ADDENDUM NO. 5

HANOVER CENTRAL HIGH SCHOOL ADDITIONS AND RENOVATIONS Cedar Lake, IN 46303

ADDENDUM FIVE

Addendum Five (AD.05) to the drawings and specifications prepared by Gibraltar Design and The Skillman Corporation for **Hanover High School Addition and Renovations** for Hanover Community School Corporation, Cedar Lake, Indiana.

© GIBRALTAR DESIGN SHEET
S-100

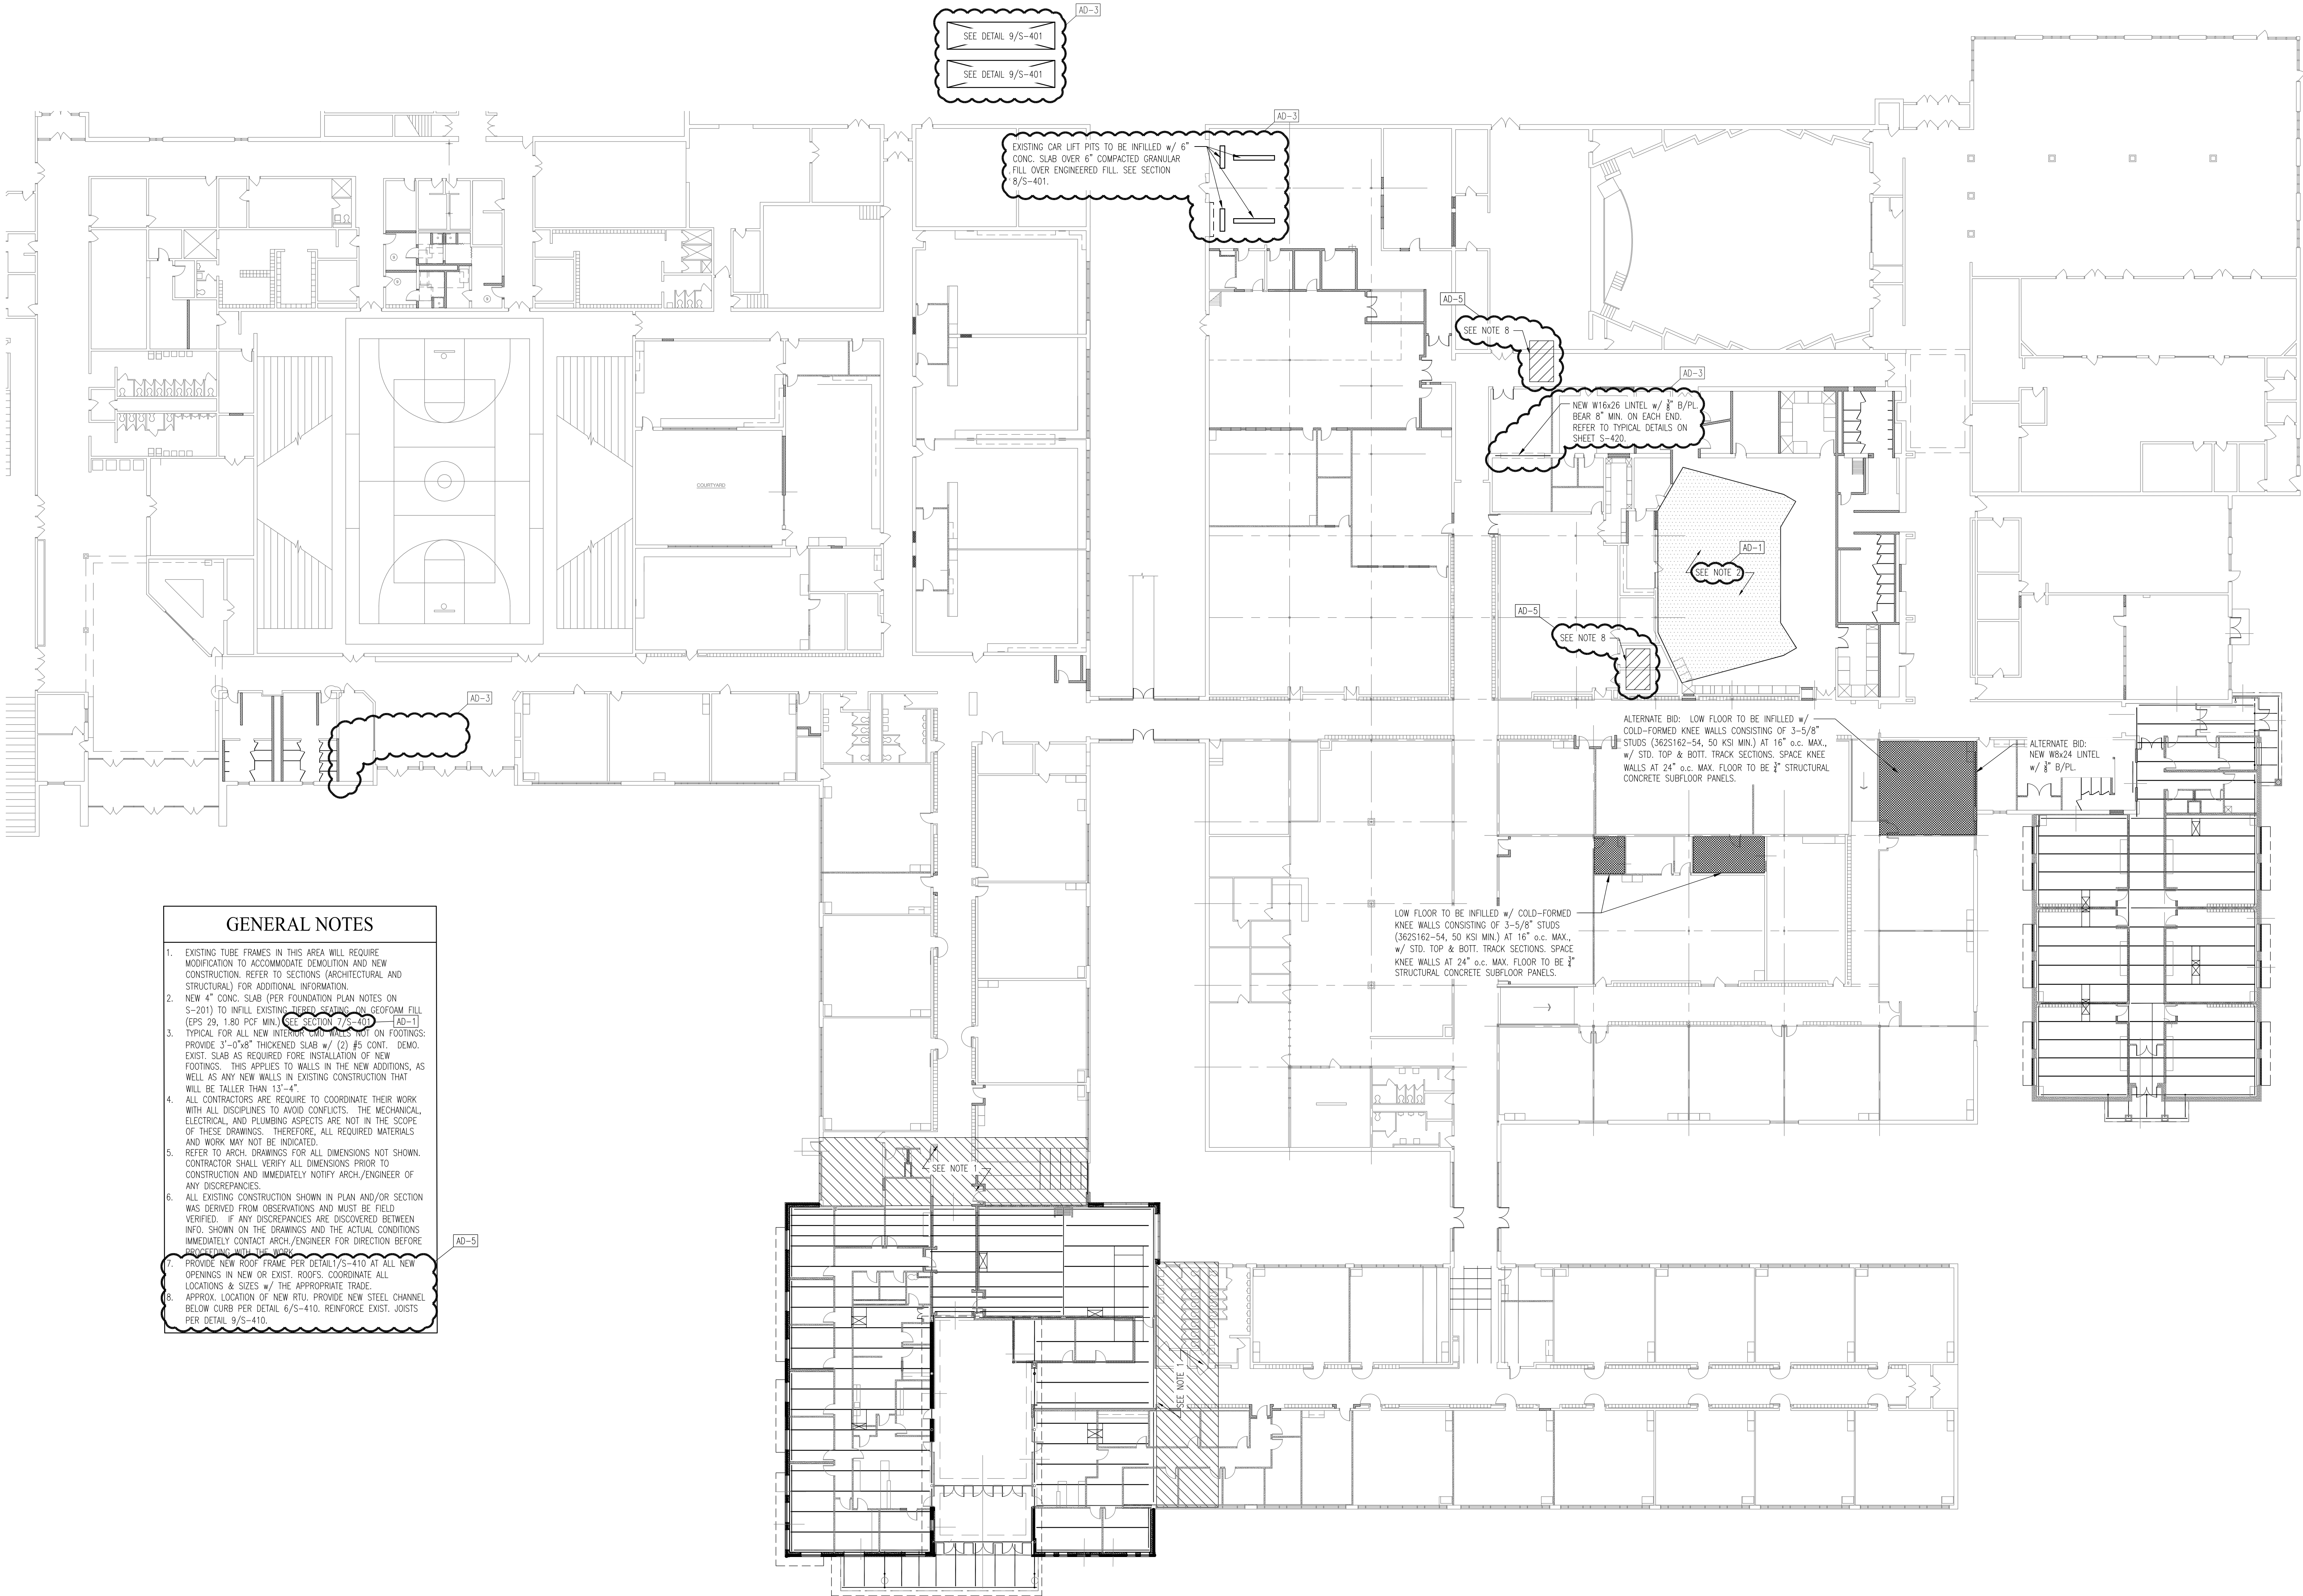
- A. Refer to revised full-size drawing, included in this Addendum, for the following revisions:
 - 1. Identified approximate locations of new RTUs in Unit E. Refer to details 6/S-410 and 9/S-410 for RTU support.
 - 2. General Notes:
 - a. Note 7 added referencing new openings in new and existing roofs. Refer to Detail 1/S-410.
 - b. Note 8 added referencing RTU support. Refer to Details 6/S-410 and 9/S-410.

S-203

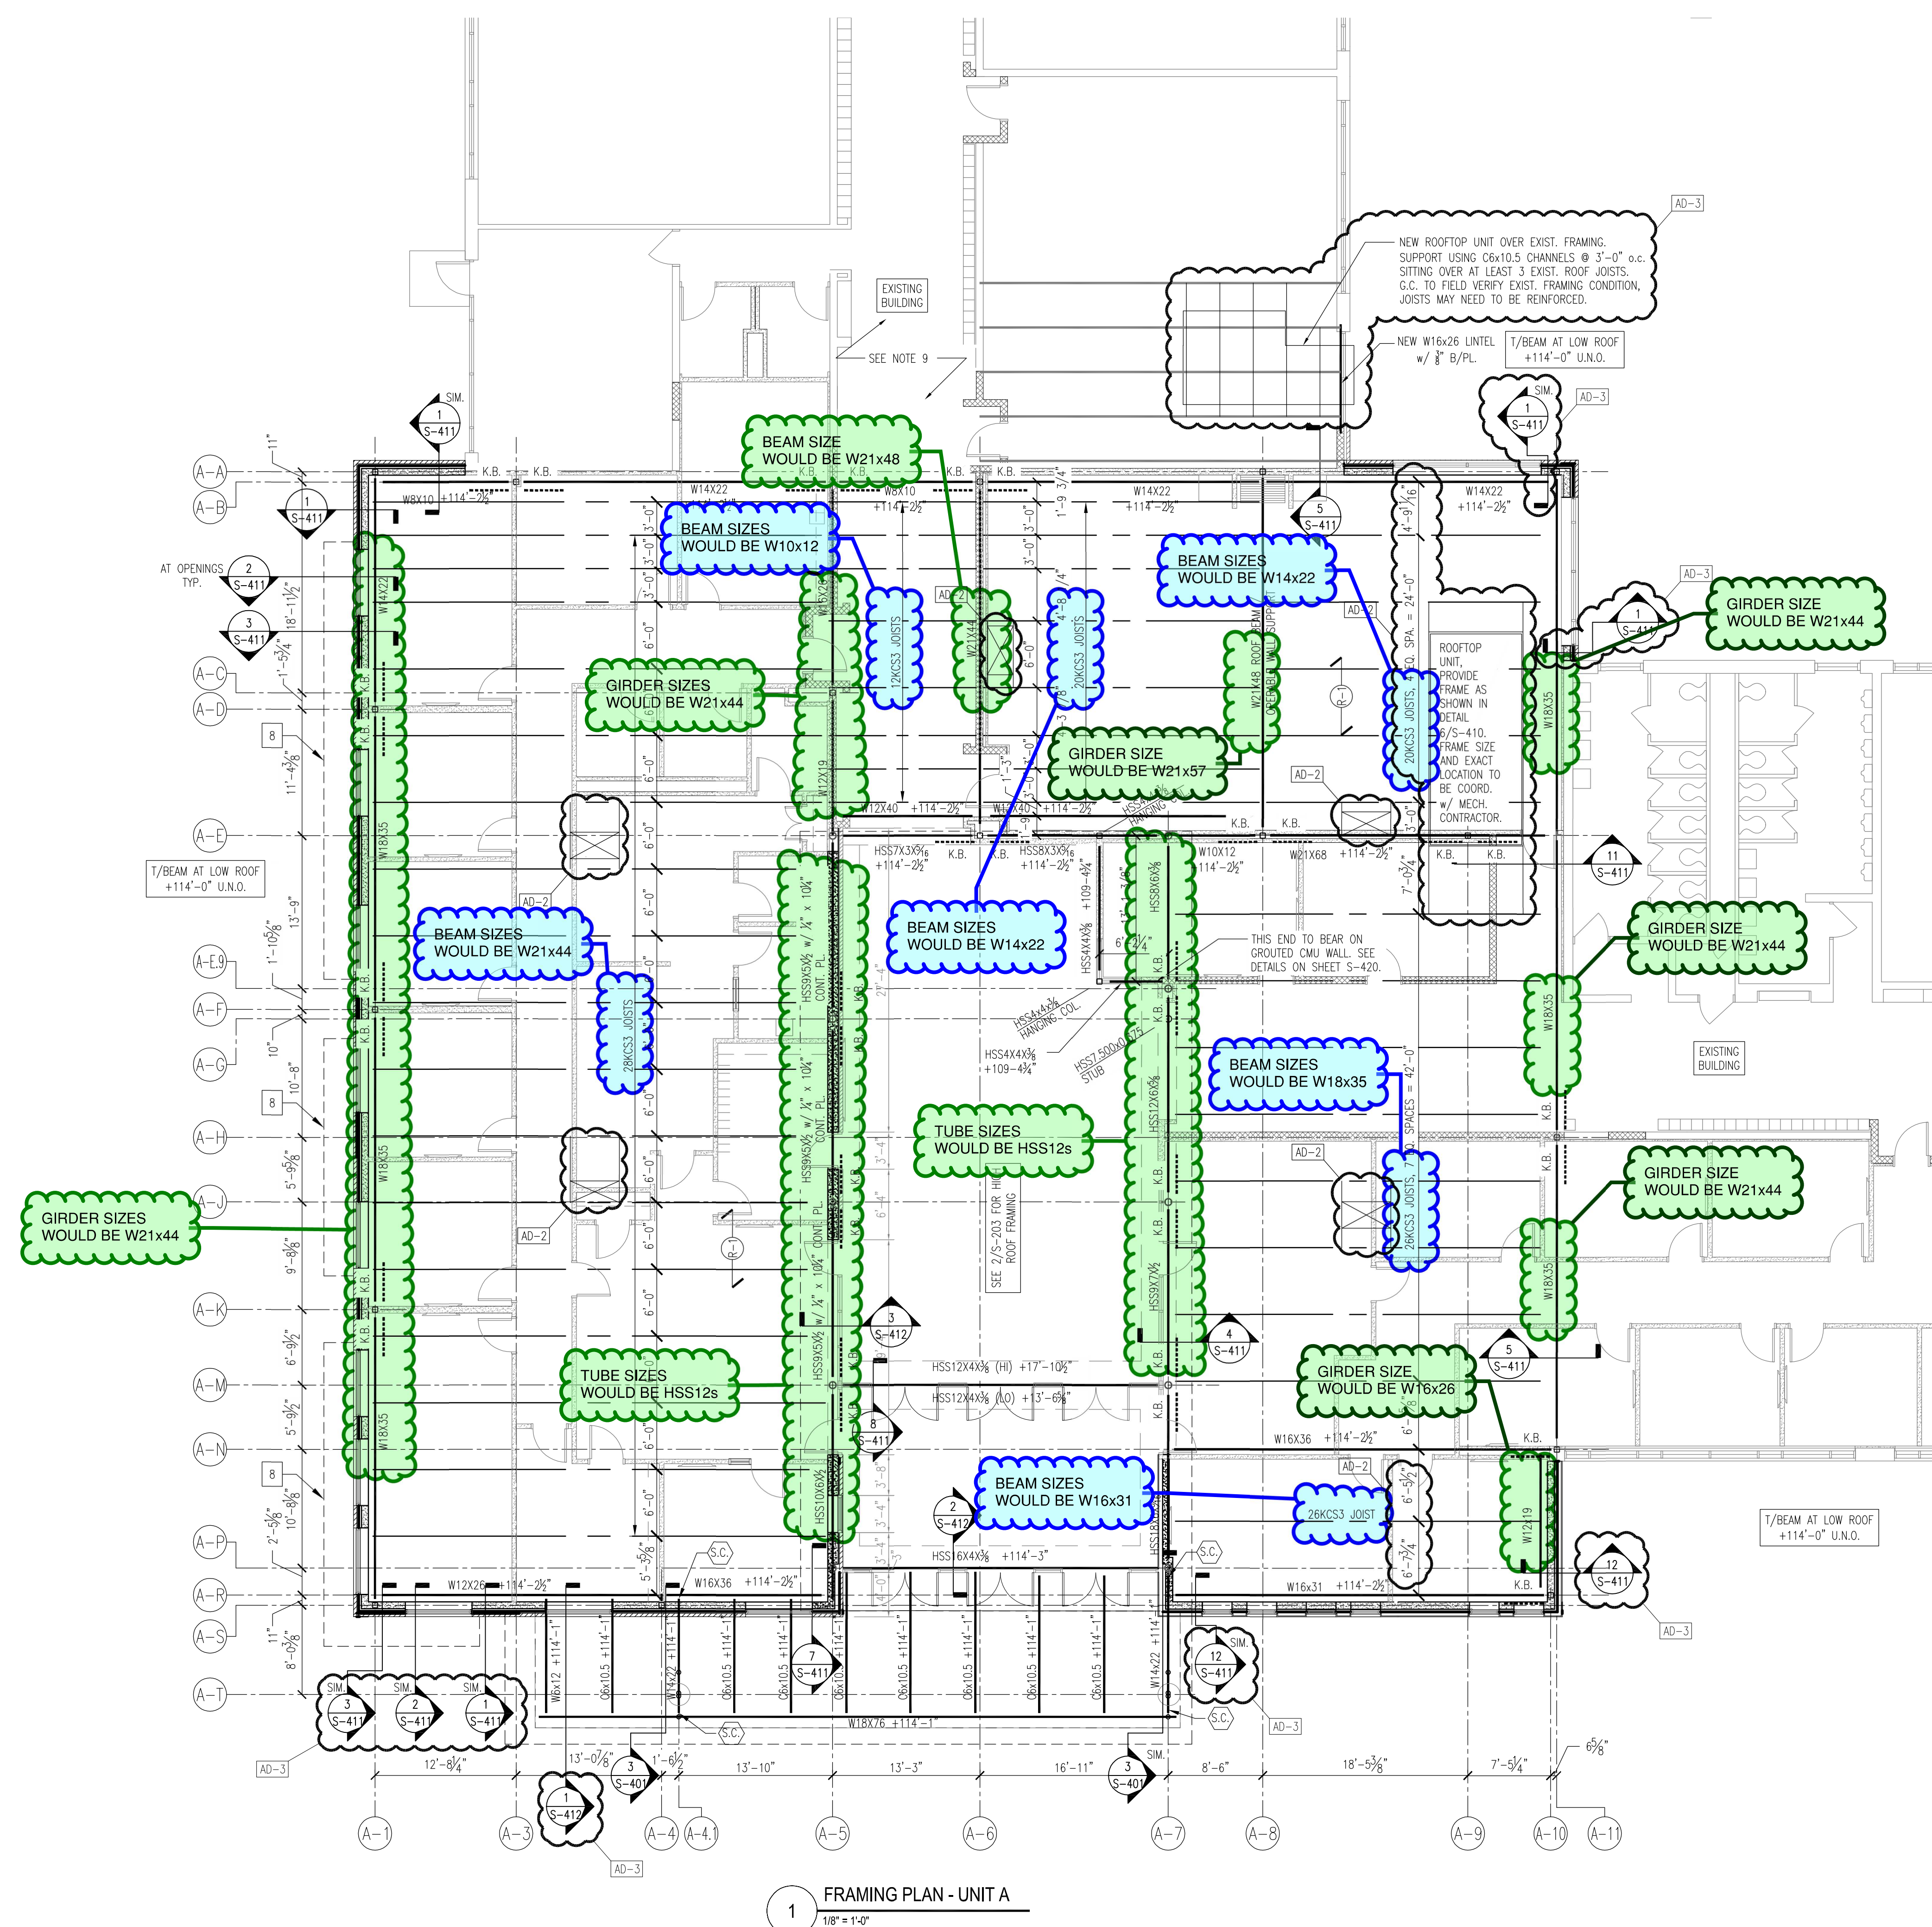
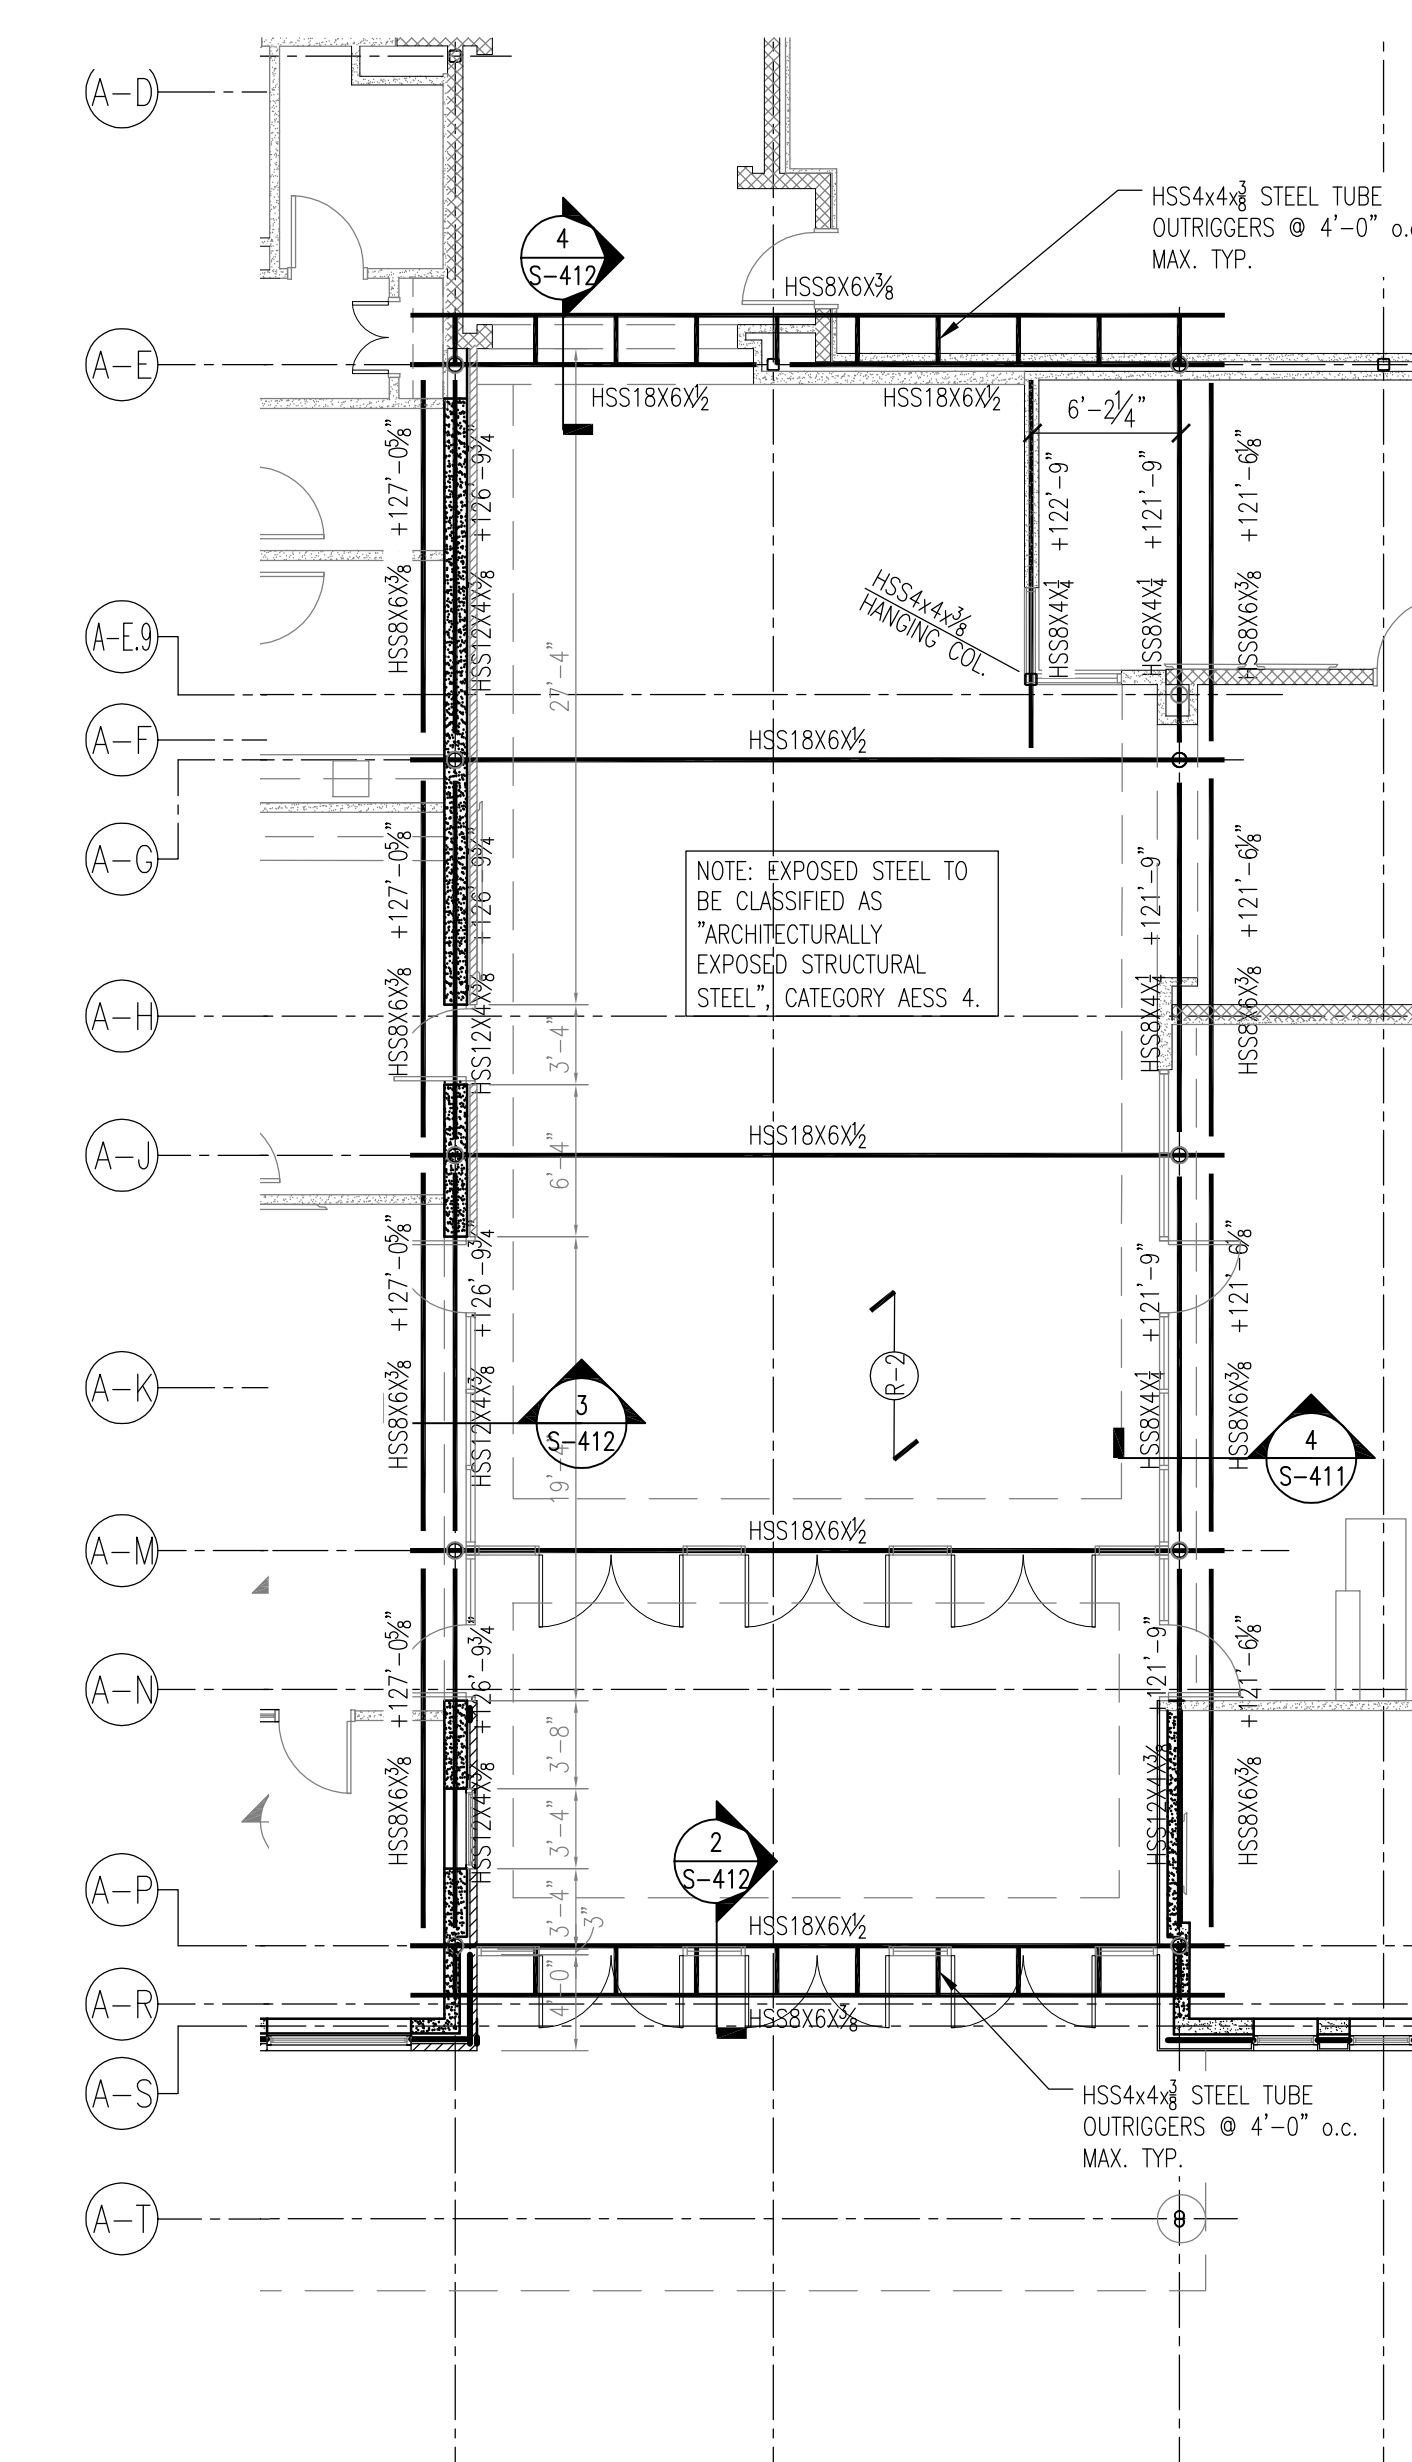
ALTERNATE NO. 9: Reference Alternate Sheets S-203 and S-204 for revisions utilizing structural steel beams in lieu of steel joists. Contractors are to use drawings/sheets as guide for size and number of revisions required and include in their pricing all necessary connections and erection considerations for a complete installation. Base Bid is to be per current construction documents (joist design).

- A. Refer to new full-size drawing, included in this Addendum.
